Staff Report to the Planning Commission

Application Number: **05-0280**

Project Description: Proposal to relocate Pajaro Valley Unified School District (PWSD) maintenance and operations facilities to a portion of the Amesti Elementary School site (APNs 050-241-15 and 16) with access off of Green Valley Road through APN 050-251-18 by demolishing existing barns and miscellaneous sheds and outbuildings and constructing three new buildings to include a 4,000 square foot office building (proposed for future construction), an 8,000 square foot warehouse/shop building, and a 22,500 square foot office/warehouse/shop building with additional mezzanine storage area of 14,062 square feet. The total proposed footprint is 34,500 square feet. The total proposed interior area, including the mezzanine storage **area**, is 48,562 square feet

INSTRUCTIONAL SL - 96 - & OPERATIONS CENTER
SANTOY, CALIFORNIA
PRELIMINARY GRADING AND DRAINAGE PLAN

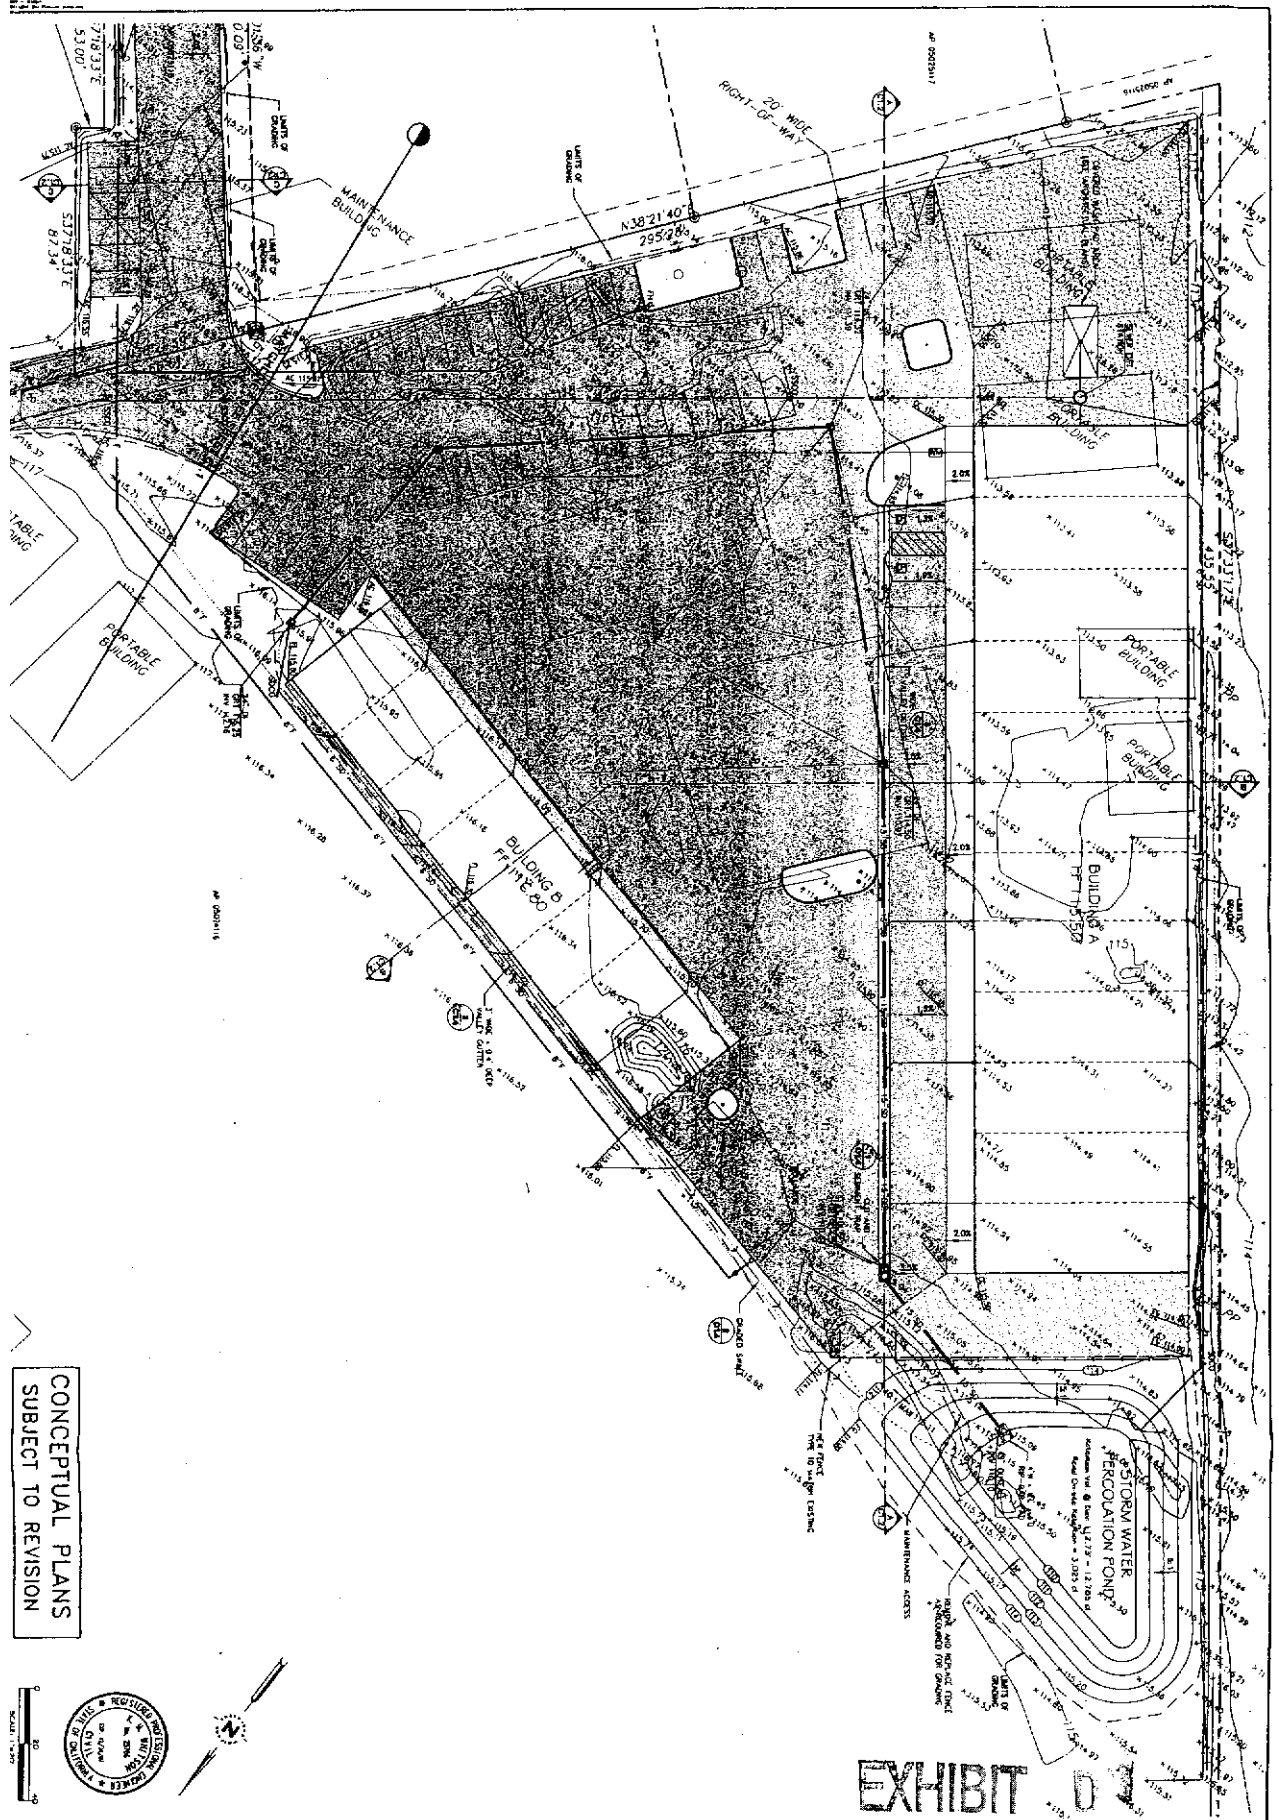
1. Comment: Sheet A-1 and Sheet L-1 show the covered wash slab parallel to Building "A", but Sheet C1.2 shows the covered wash pad area oriented perpendicular to Building "A" and says to see Architectural Plans, but none were included. Please clarify orientation of covered wash and include elevations.

Response: *The covered wash pad that is indicated on the Civil plans is a graphic representation only. The Architectural plans (Sheet A-1) provide the detailed layout of the wash area. The purpose of the wash pad cover is to keep stormwater off the wash slab, which has a clarifier and discharges directly into the sanitary sewer system. Elevations and details for the "cover" have not been developed at this time, but will be included in the final plans submitted to the County for Building Permit. This cover will be a freestanding steel structure that is open on all sides and approximately 14-feet in height. It will have a corrugated steel roof that is similar to the material used on the main buildings and minimally sloped for drainage.*

FIGURE 2.2
Preliminary Landscape Plan

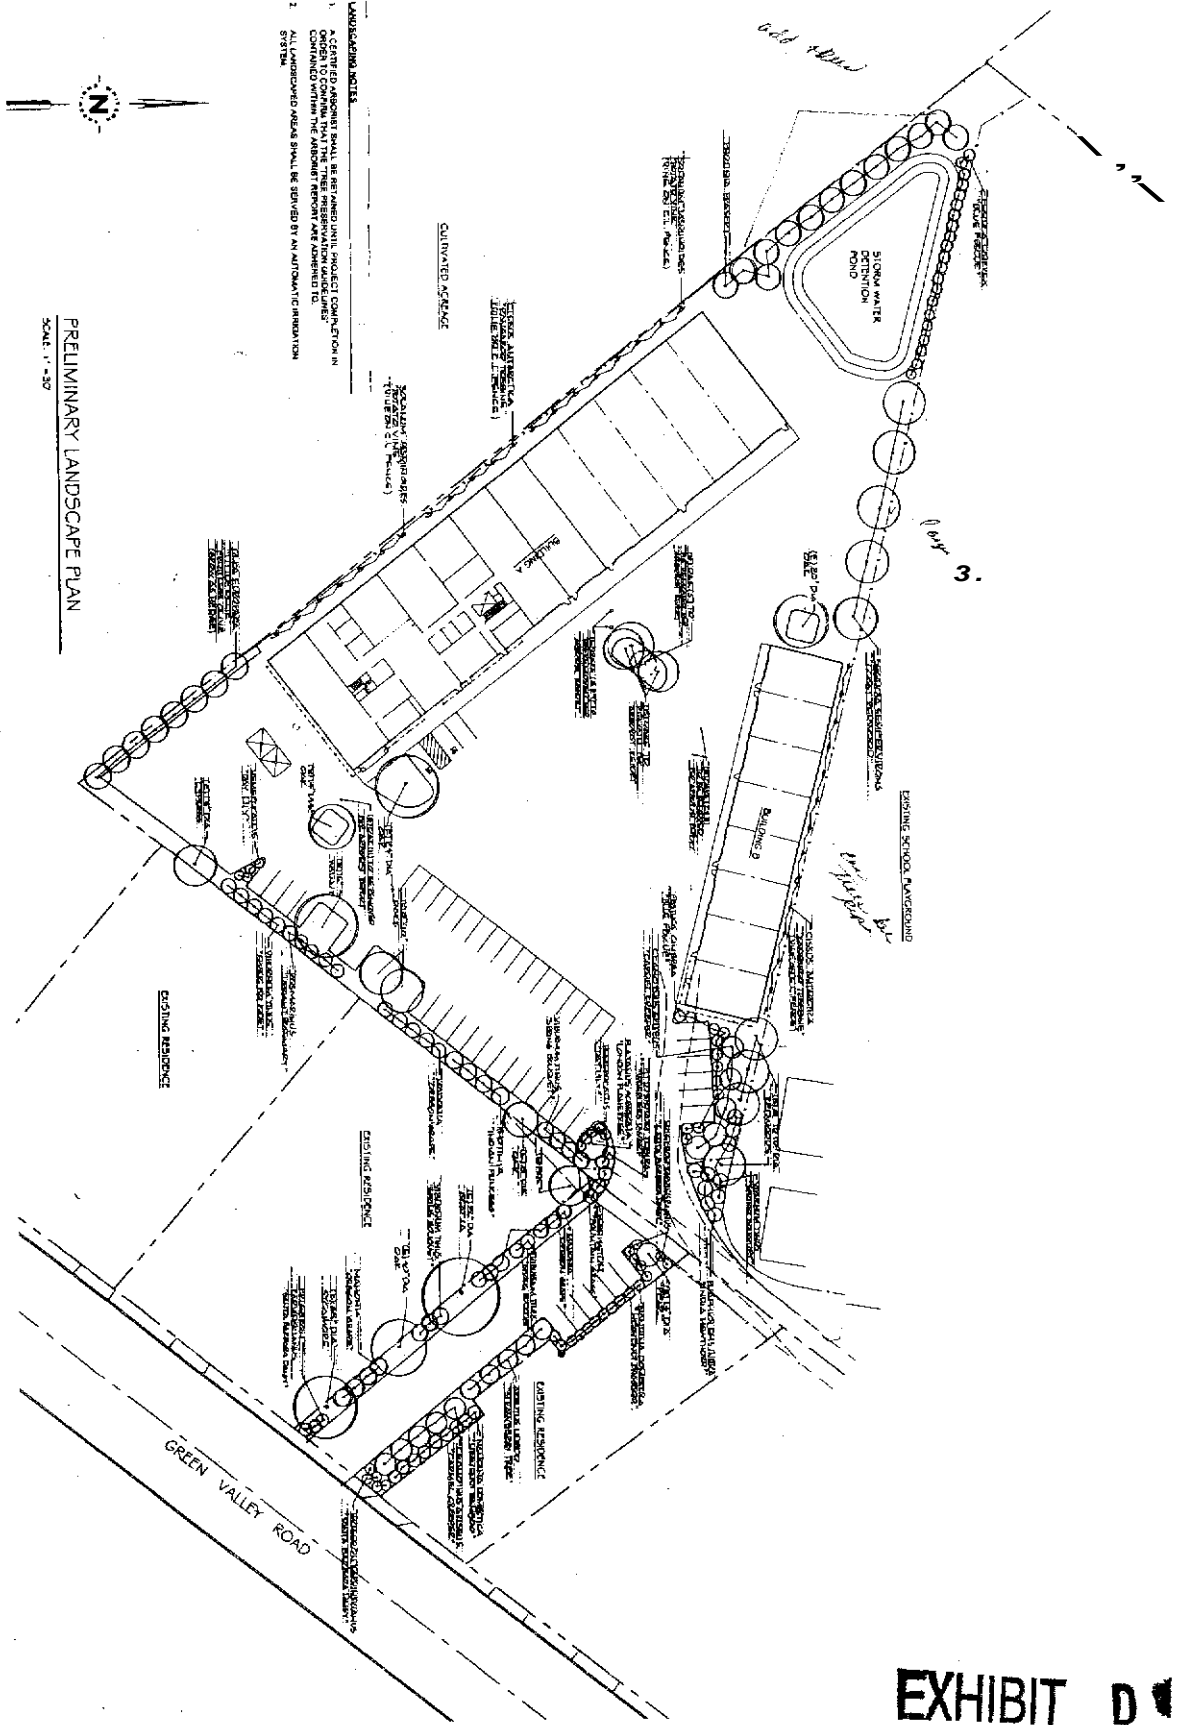
The only condition that we would not agree to is the requirement that all shrubs shall be planted at a 5-gallon size (minimum). We believe that this requirement, as stated, would place an undue financial burden on the project and request that it be changed to the text noted below. As the final plans for the project are being prepared, the District is willing to investigate the possibility of increasing the size of certain shrubs based upon their location and potential to provide a more immediate impact to the appearance of the facility upon completion. This could occur in selective locations, such as at building entries or planter islands. The final landscape plans submitted to the County for permit shall include the following information:

1. All shrubs shall be planted at a 1-gallon size (minimum).
2. Ground cover shall be planted at all "blank" areas shown on the preliminary drawings.
3. A minimum 2" thick bark mulch shall be provided at all planting areas.
4. Drip irrigation shall **be** used whenever possible.
5. Concrete curbs (6 high) or bollards shall be used to protect planting areas.
6. Coordinate plant selection (water tolerant) for the percolation swale at the project's entry.
